**DESIGN MEMORANDUM 1
GENERAL DESIGN**

**MURRELLS INLET NAVIGATION PROJECT
GEORGETOWN COUNTY, SOUTH CAROLINA**

**REVISION OF
WEIR SYSTEM AND
JETTY & CHANNEL ALIGNMENTS**

SUBJECT: Murrells Inlet, South Carolina - Supplement No. 1 to the
General Design Memorandum - Revision of Weir System and
Jetty and Channel Alignments

JETTY PROFILE

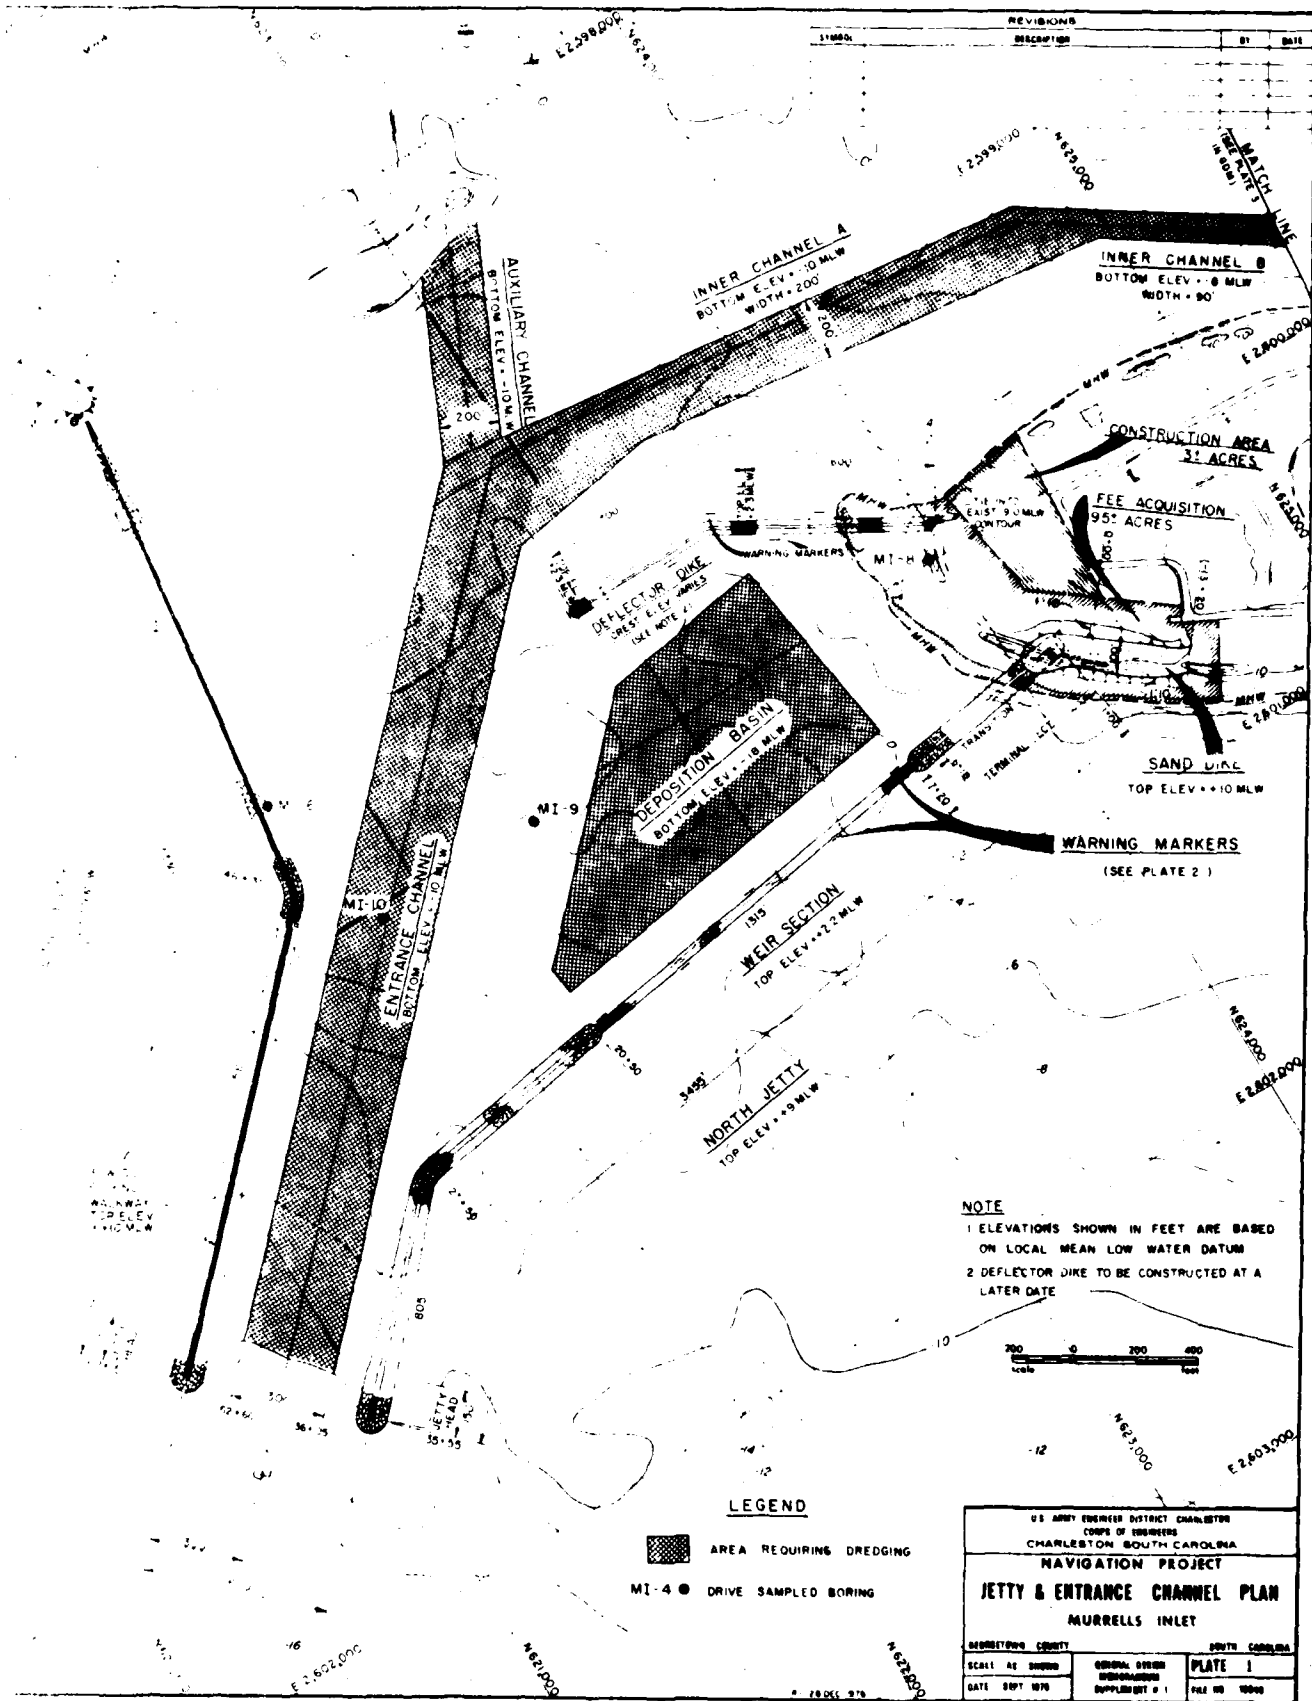
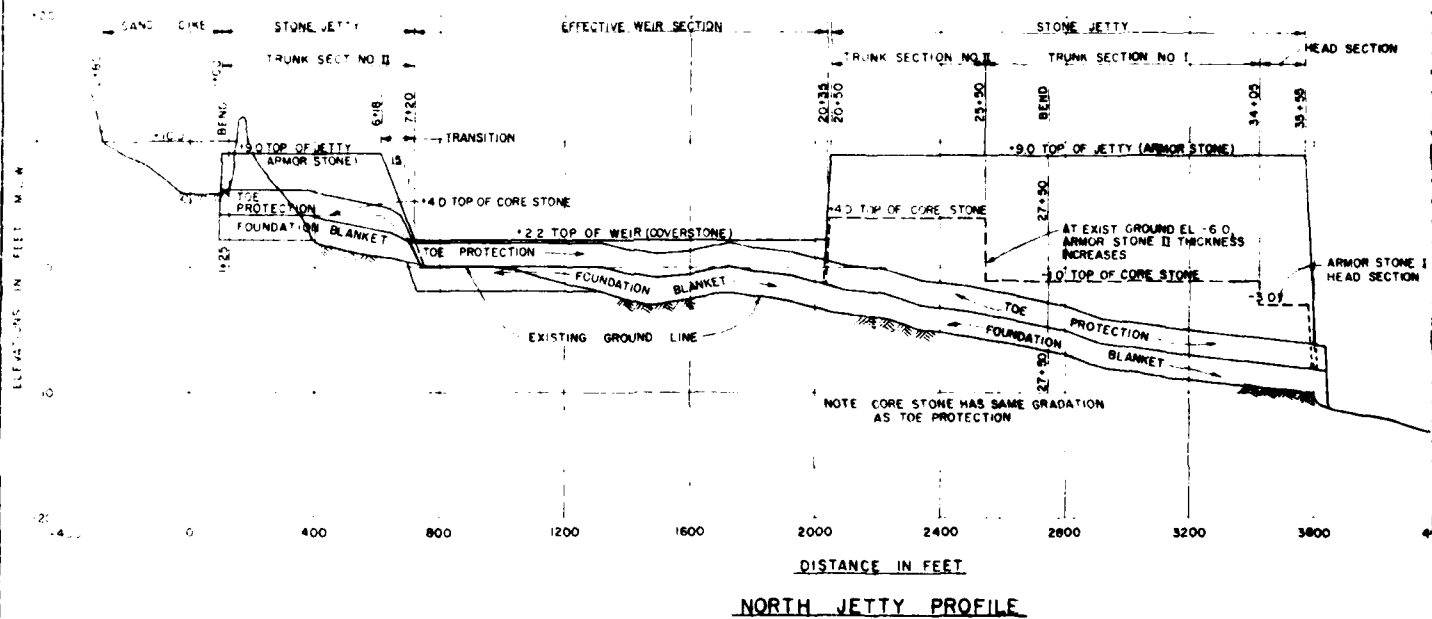
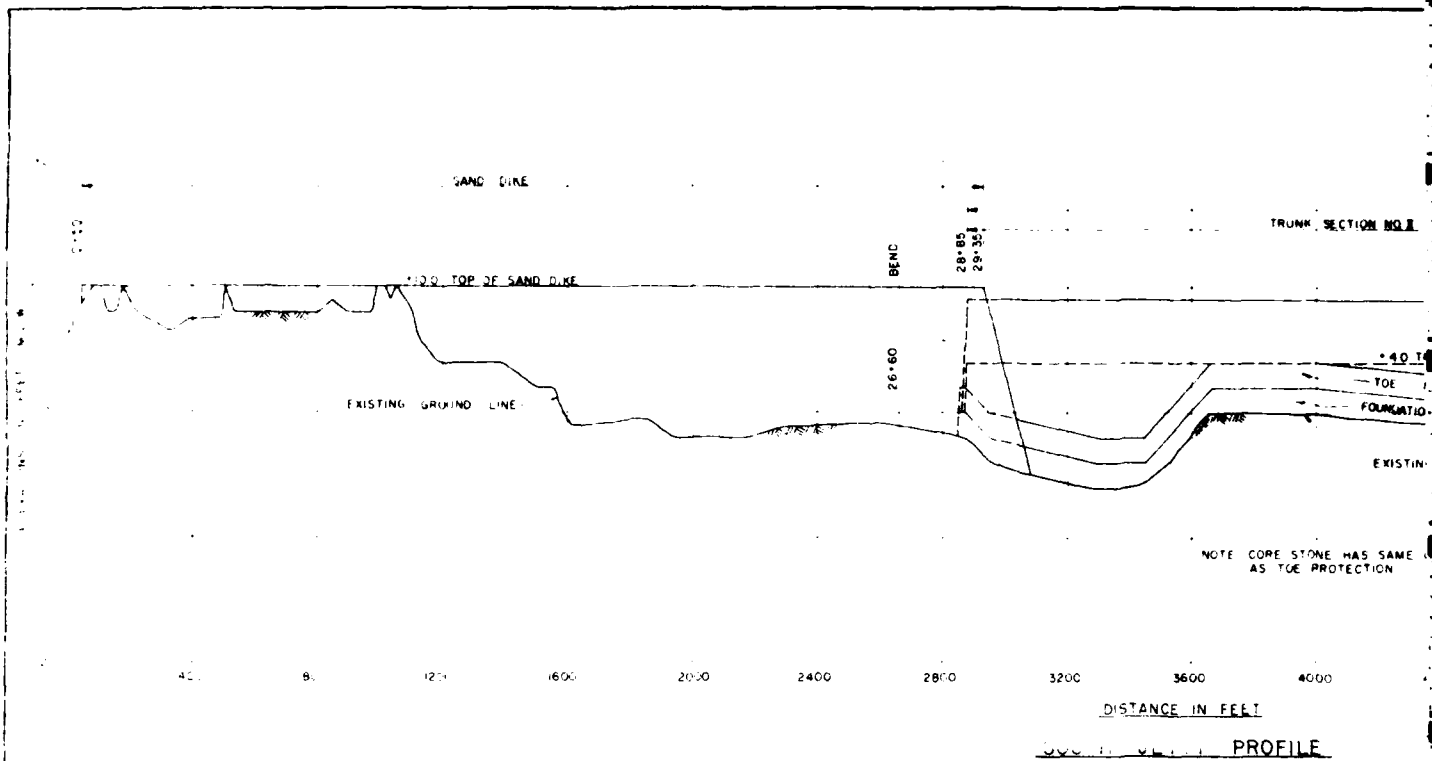
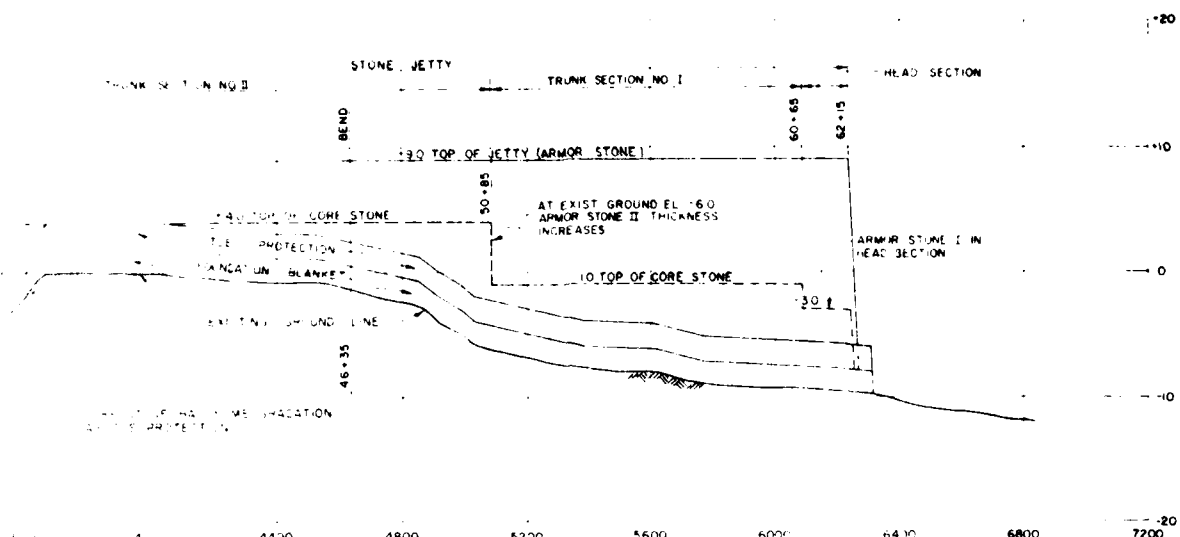
16. Jetties. Jetty spacing was reduced as a result of model testing. See subparagraph 10d (1), above for details. A jetty trunk section has been added to facilitate transitioning between the stone weir and the high land on the Garden City peninsula.

17. Weir. The weir section of the north jetty system has been changed from a concrete sheet pile type proposed in the GDM to a stone type. This change resulted from a conference at SAD on 20 August 1976 attended by representatives from CERC, OCE, SAD, and interested Districts of SAD. The stone weir system would be constructed to function in the same manner as the previously proposed concrete pile type. In effect, the weir crest would be established low enough to allow longshore drift to bypass into the deposition basin, but high enough to protect a dredge operating in the deposition basin under reasonably stable weather conditions.

Structurally, the stone weir system would have characteristics similar to the stone jetties. This system would be constructed of a foundation blanket, toe protection and armor stone (see Plates 2 and 3). The newly designed weir system is considered justified because of the following advantages over the concrete sheet pile weir.

FIGURE 13

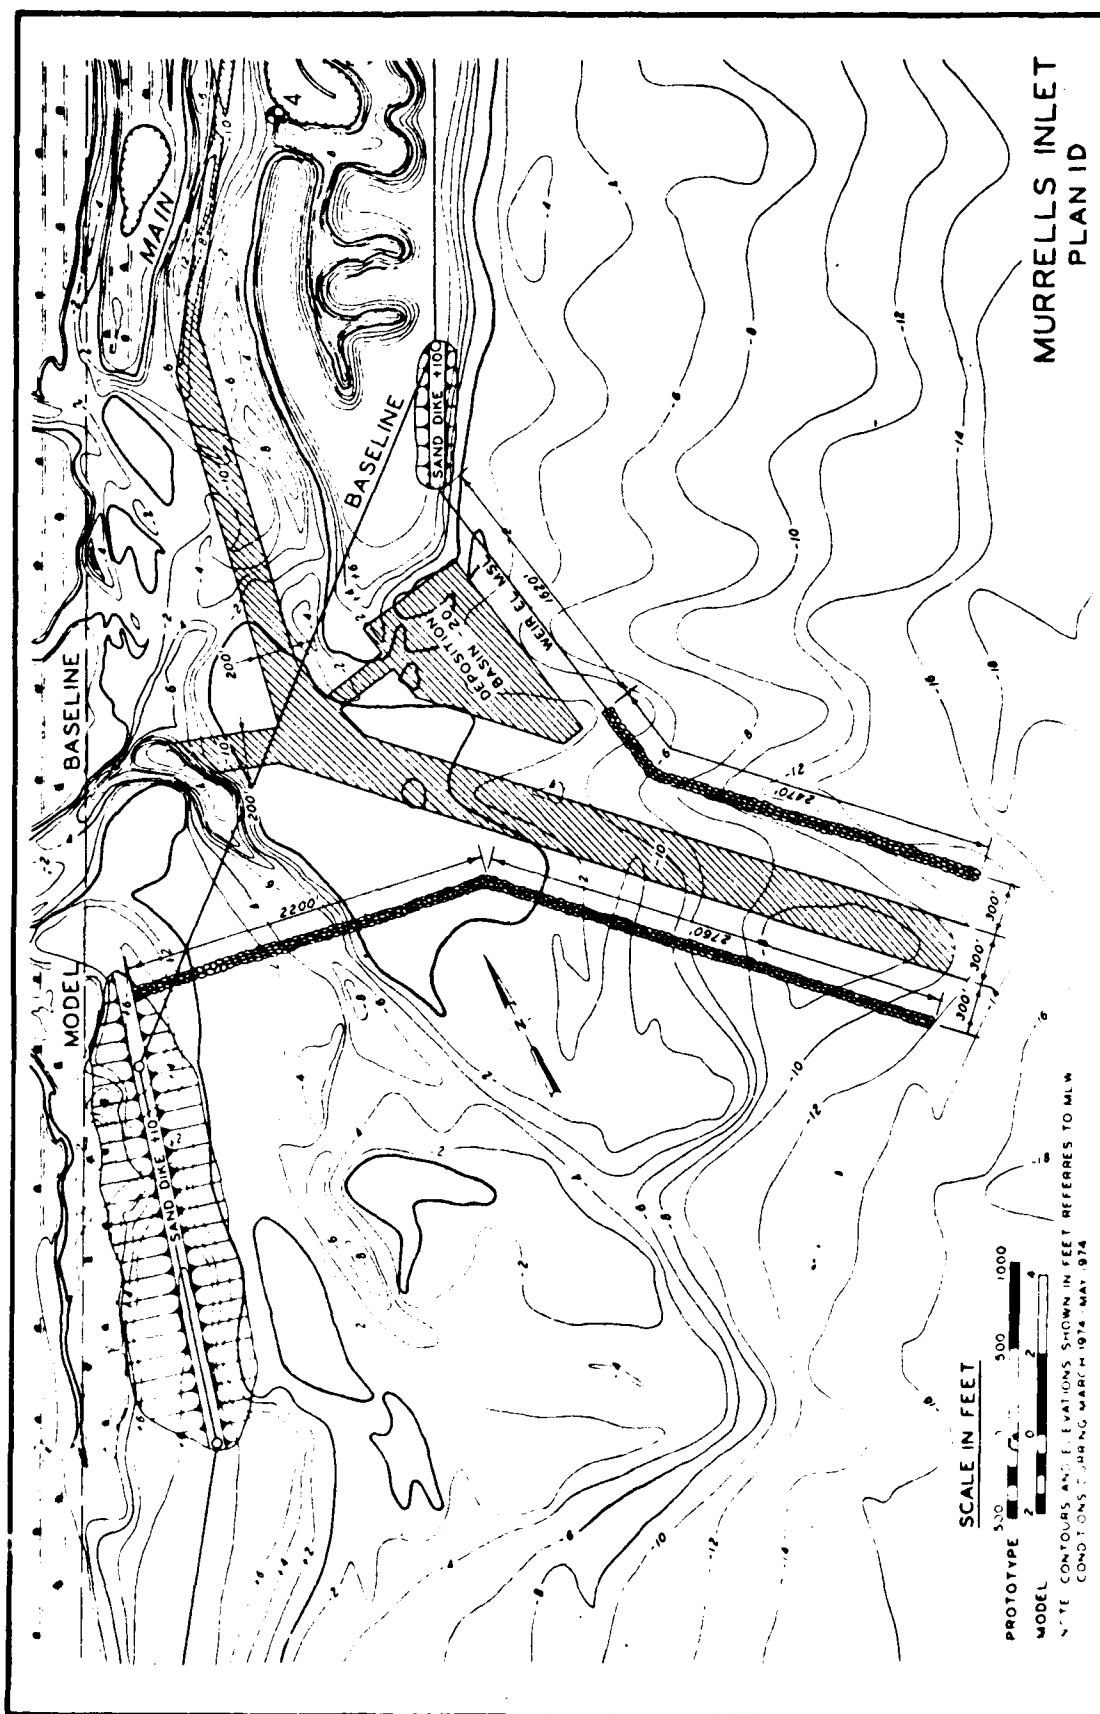
d. Plan 1D. As a result of testing and evaluation of Plan 1C and in recognition of the channel depth changes in the GDM plan, the following major revisions were made to develop Plan 1D (Figure 13):

(1) The jetty spacing was reduced from 900 feet to 600 feet wide to enhance the flushing action by increasing the velocity in the entrance channel.

(2) The proposed entrance channel was reduced in depth from -12 feet mlw to -10 feet mlw in order to increase the ebb velocities so that the probability of channel shoaling would be reduced.

(3) The depth of the proposed auxiliary channel leading to Oaks Creek was increased from -6 feet mlw to -10 feet mlw and the width was established at 200 feet to reduce the high velocities that could cause scouring and navigation hazards to smaller boats.

(4) The width of the initial section (Inner Channel A) of the proposed inner channel was increased from 90 to 200 feet; and, the depth was increased from -8 feet mlw to -10 feet mlw.

FIGURE 16A

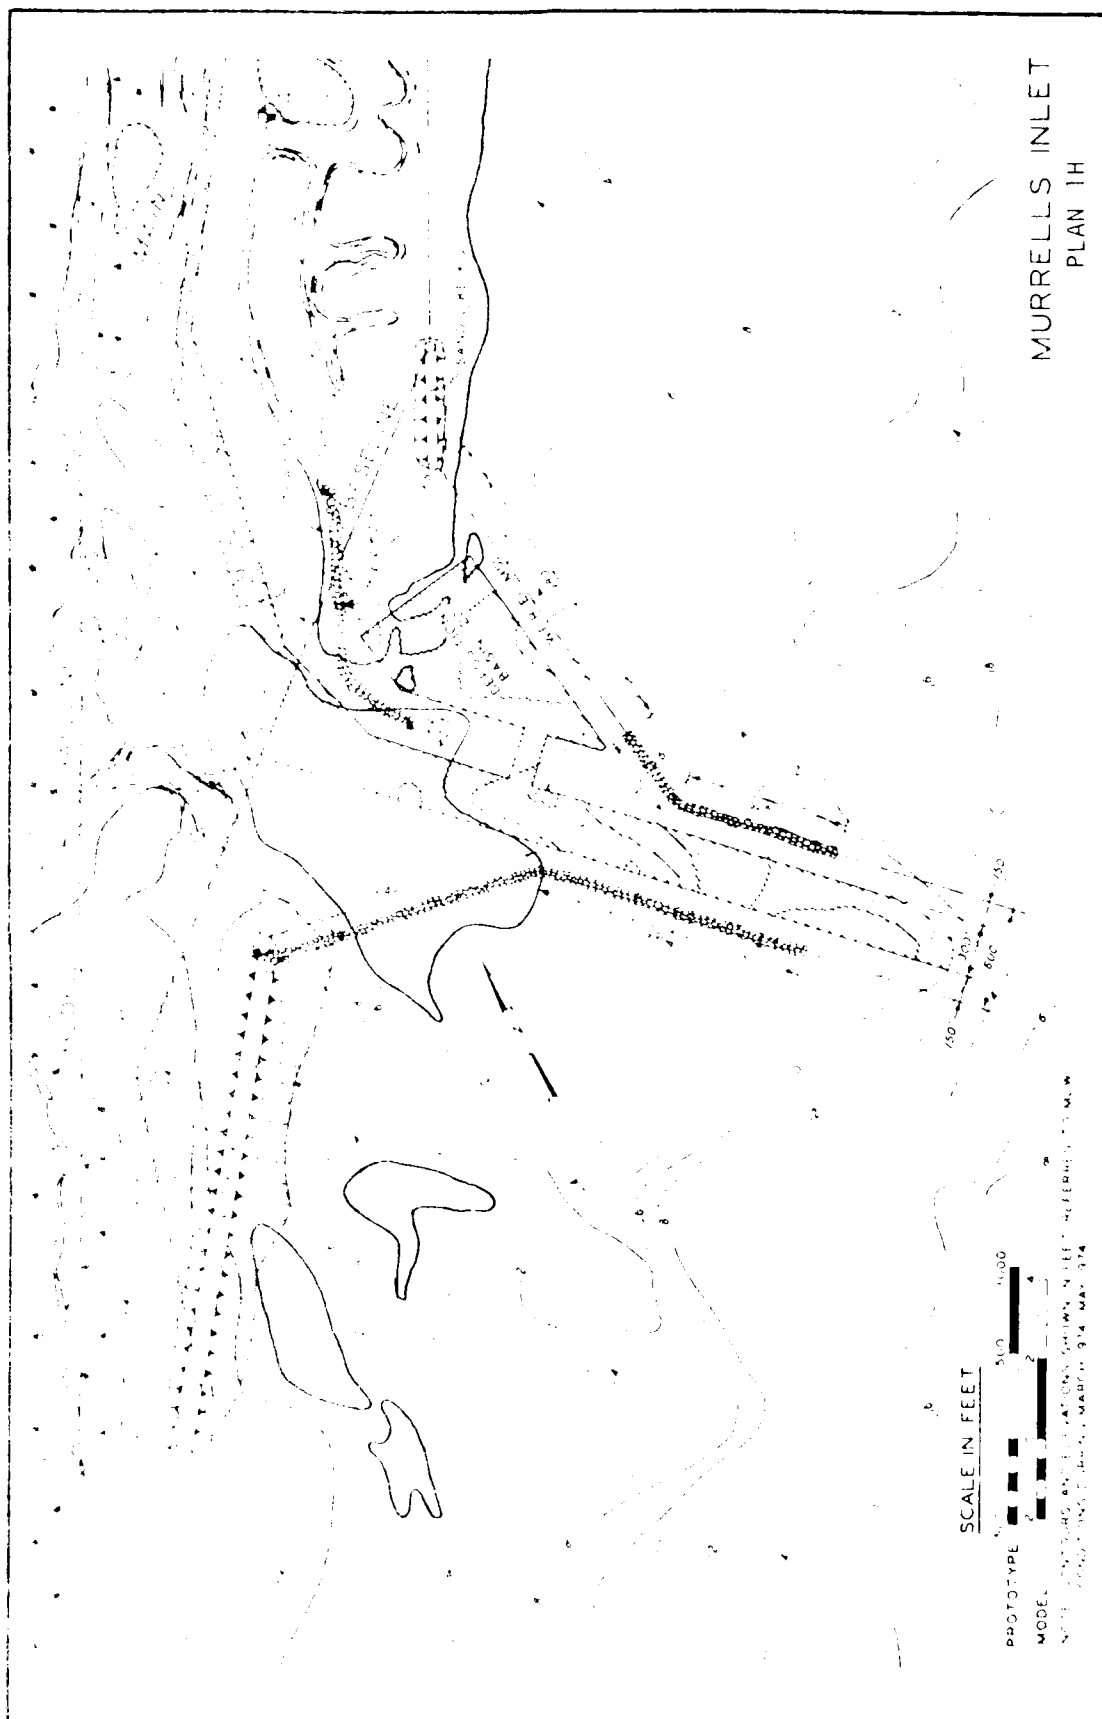
i. Plan 1H. Plan 1H (Figure 16a) was developed to improve hydraulic characteristics through the weir and deposition basin during flood flows. This plan is identical to Plan 1G except that the training dike has a crest of varying elevation. Starting at the dune line, the crest varied from +9.0 feet mlw to +2.3 feet mlw approximately 600 feet from the dune line; thence, remained constant at +2.3 feet mlw to the end of the dike. This plan produced the most favorable results of all the previous model testing.

11. GDM Supplement Plan. At WES' recommendation, Plan 1H has been adopted as the project plan for presentation in this GDM Supplement. However, the District proposes not to construct the deflector dike as a part of initial construction. The reasons for this decision are as follows:
